SURFACE VEHICLE INFORMATION REPORT -DRAFT

J2915™

H-III5F Spine Box Update to Eliminate Noise

This SAE Information Report documents the problems with the 2002 regulated version of the spine box, and defines a recommended solution to resolve the problem.

Figure 1 - Spine rocking on screws

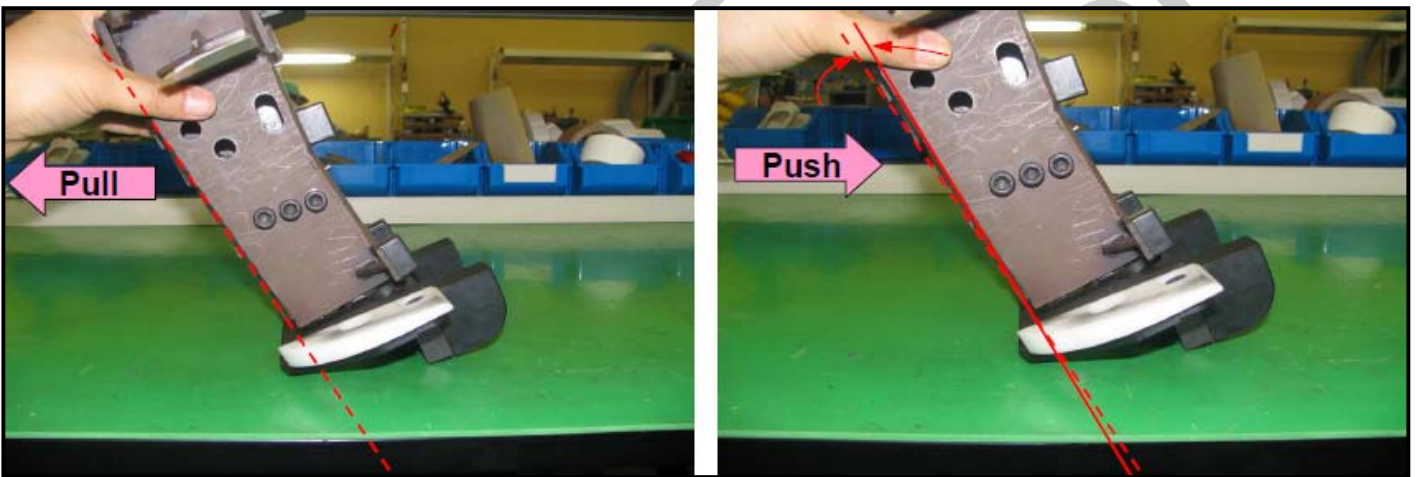
In the thorax region of the H-III5F, the spine box (880105-1000) is attached to the thorax load cell simulator (880105-328) by six 5/16-18 x ½ inch SHCS (item 29 on 880105-300). Since the holes in the spine box are 0.323 inch diameter and the screws have a maximum diameter of 0.313 inch, there is always clearance between the screws and the spine box wall. As the H-III5F is exposed to the accelerations involved in sled or crash testing, the screws can loosen and the spine box will slip under the screw heads until it hits the sides of the screws. This motion produces high amplitude, high frequency mechanical noise on accelerometers within the dummy - which is an artifact of the dummy. A secondary effect of this rocking motion is that the spine box can move approximately ± 1 degree relative to the thorax load cell structural replacement (see Figure 1). This moves the head position relative to the pelvis fore and aft based on how the spine box is in contact with the screws.

Figure B1 - Modified SHCS 5/16-18 x 1/2"

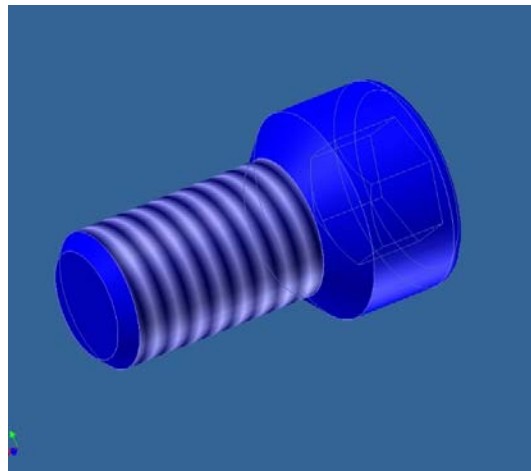
The clearance between the six screws connecting the spine box to the thorax load cell (or structural replacement) with the 2002 Final Rule dummy can allow a range of positions and loosening during tests. This procedure can be used between tests to make sure the screws are centered and tight. This procedure can be carried out with any level of build, including a full dummy between tests. *This procedure is not needed once the upgrade recommended in section 0 is completed.*

1. Remove jacket.
2. Loosen attachment screws for #3 and #5 ribs.
3. Remove #4 rib.
4. Loosen all six screws connecting spine box to thorax load cell (or structural replacement).
5. Remove front and back screws on one side.
6. Install modified screw (see Figure B1) in the front and back locations on one side (see Figure B2).
7. Tighten the other four screws to 22 Nm (195 lbf-in).
8. Remove two modified screws.
9. Install front and back standard screws and tighten to 22 Nm (195 lbf-in).
10. Install #4 rib.
11. Tighten attachment screws for #3 and #5 ribs.
12. Install jacket.
